## **Docket No. 272 - Development and Management Plan Inspection**

## **Segment 2a Inspection**

**Date: January 22, 2008**

Location: Segment 2a - Beseck Switching Station to Cheshire/Hamden Town Line

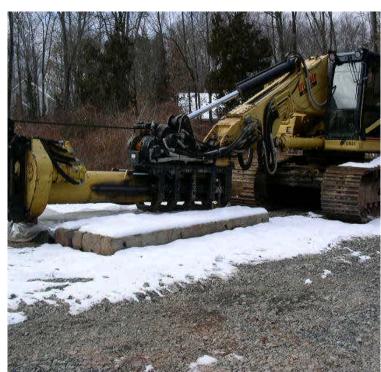
Tamarack Swamp: Foundation drilling underway. Small stockpiles associated with drilling were noted. Controls are in place.
